MEMORANDUM

Re: Review of Retaining Wall
Slope Stability Analysis
Vidal Street Bridge, Sarnia
W.O. 93-11003, Site 14-76
District 1, Chatham

**RE: SLOPE STABILITY ANALYSIS
VIDAL ST. BRIDGE - SARNIA APPROACH
ST. CLAIR RIVER TUNNEL PROJECT
SARNIA, ONTARIO**

Re: Review of Retaining Wall
Vidal Street Bridge, Sarnia
W.O. 93-11003, Site 14-76
District 1, Chatham

SECTION A-A

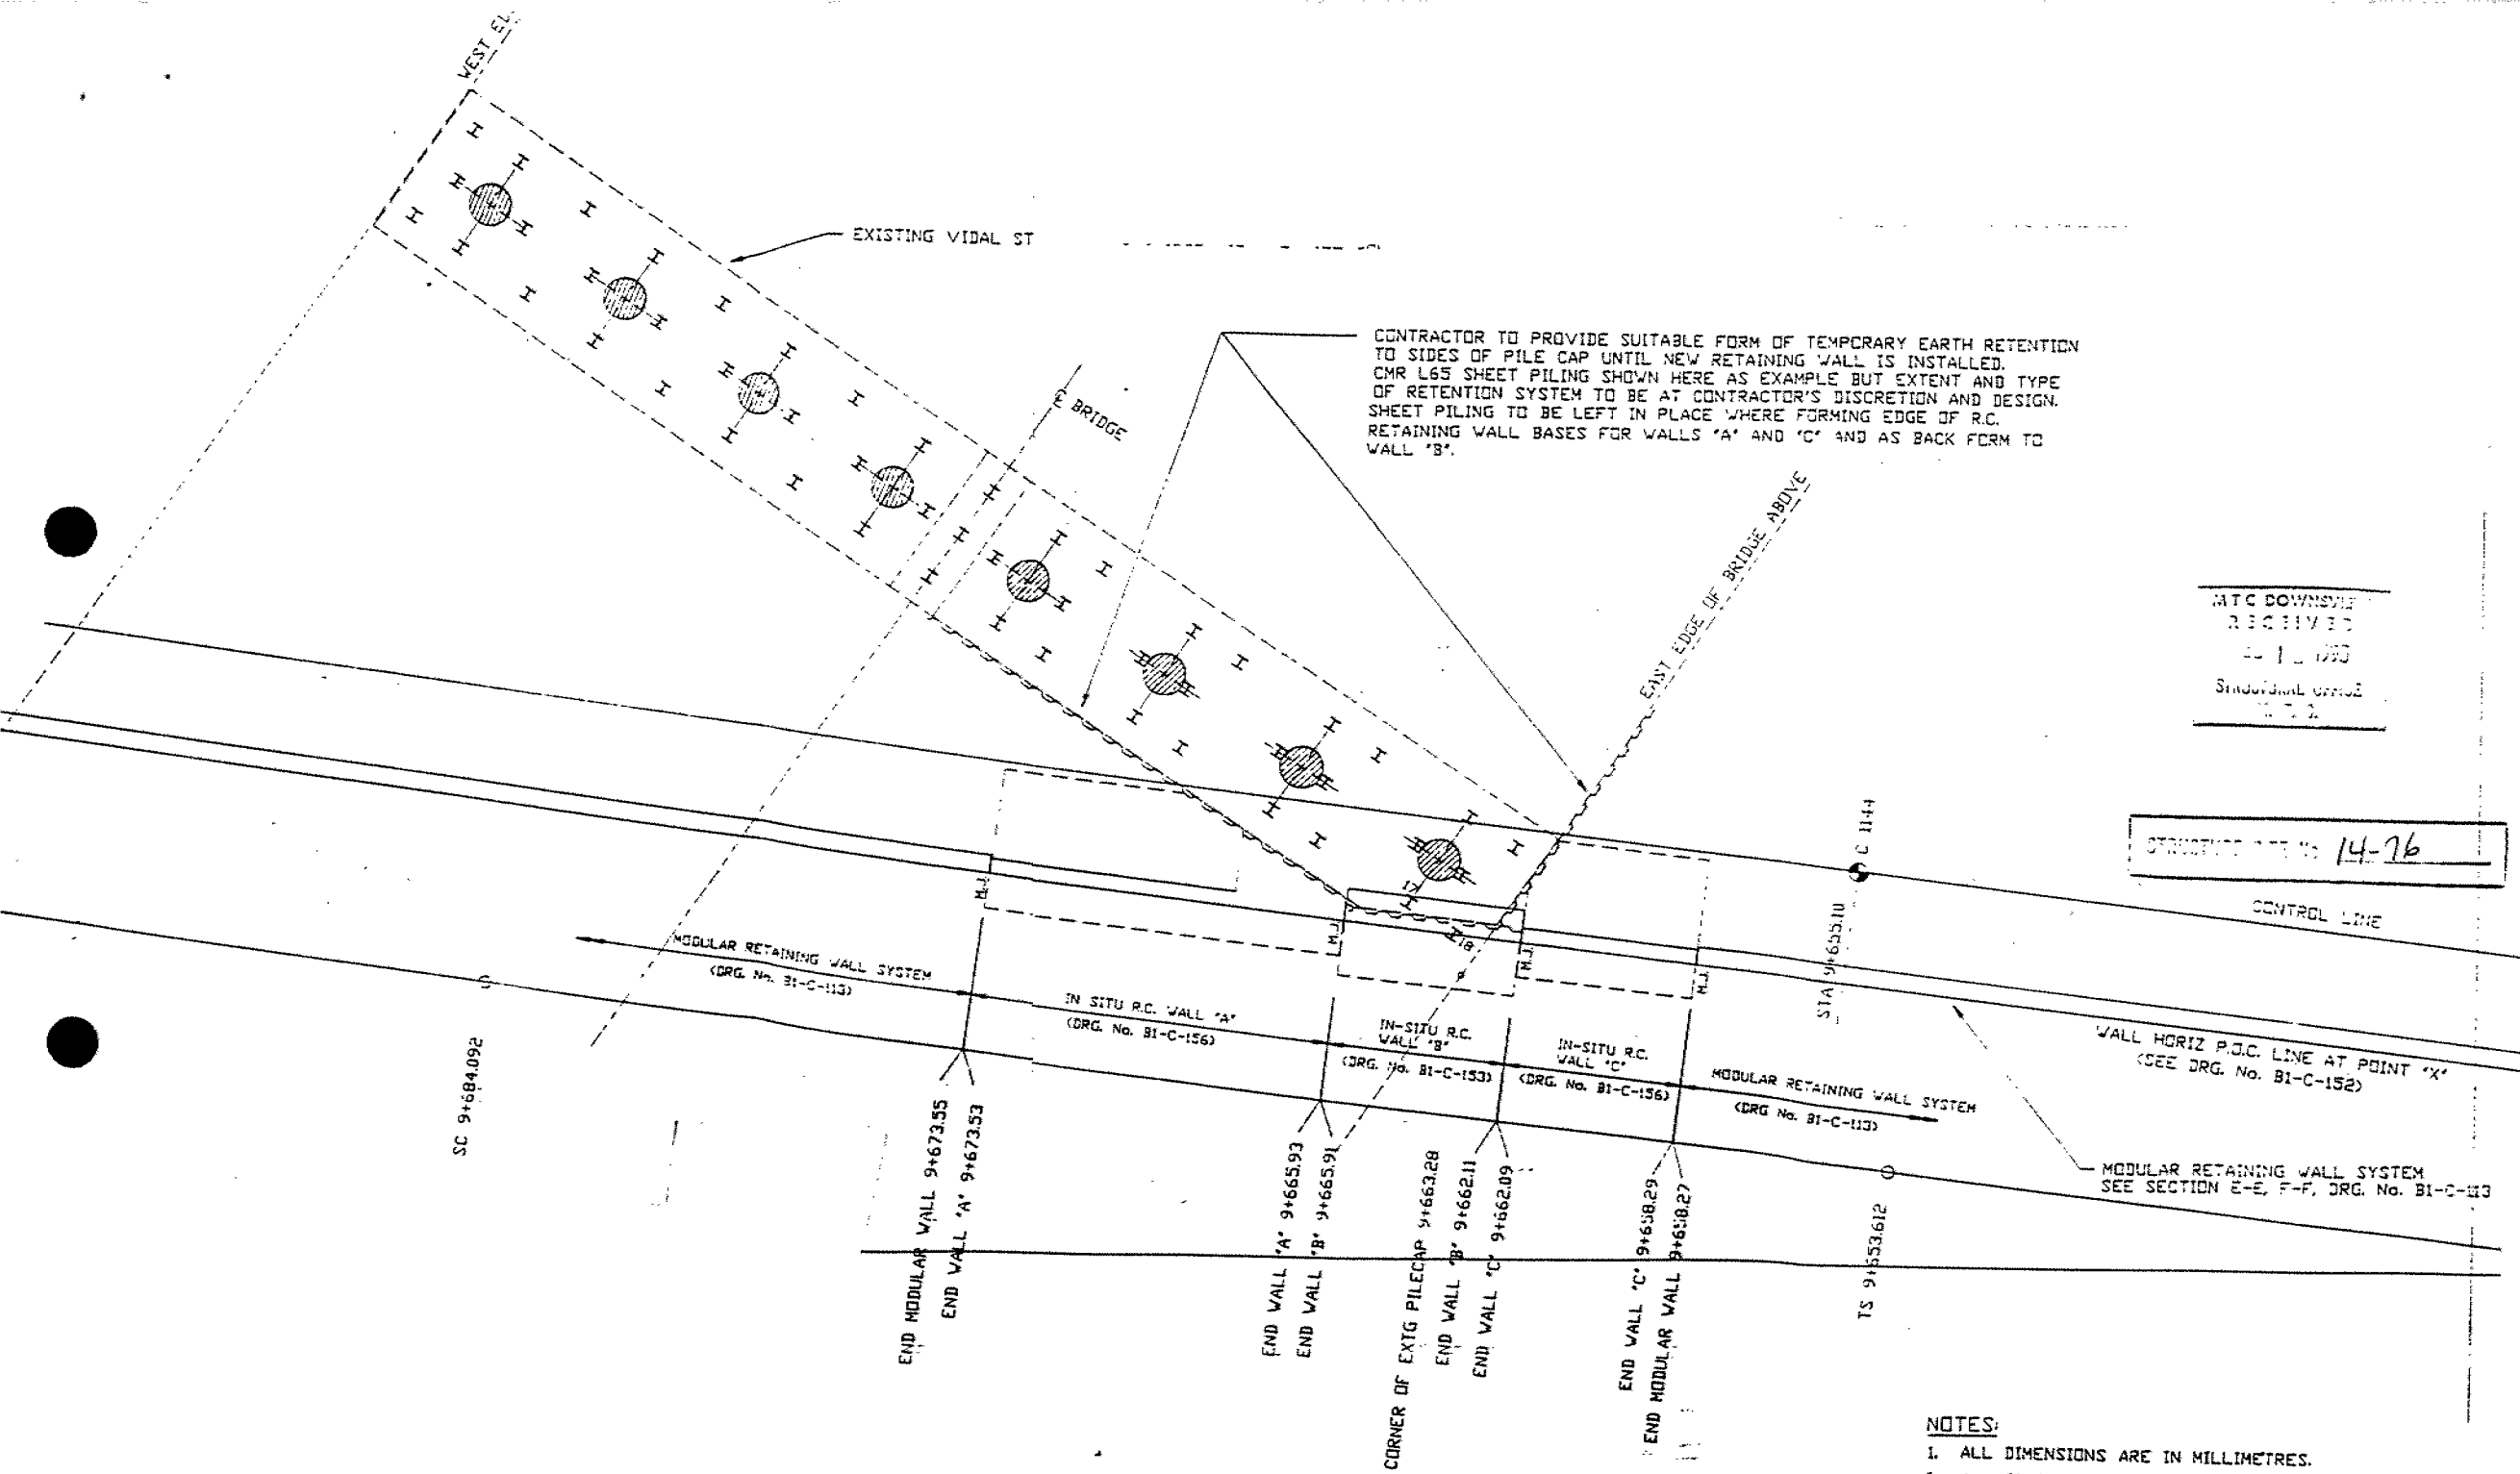
do not need
prob rolling
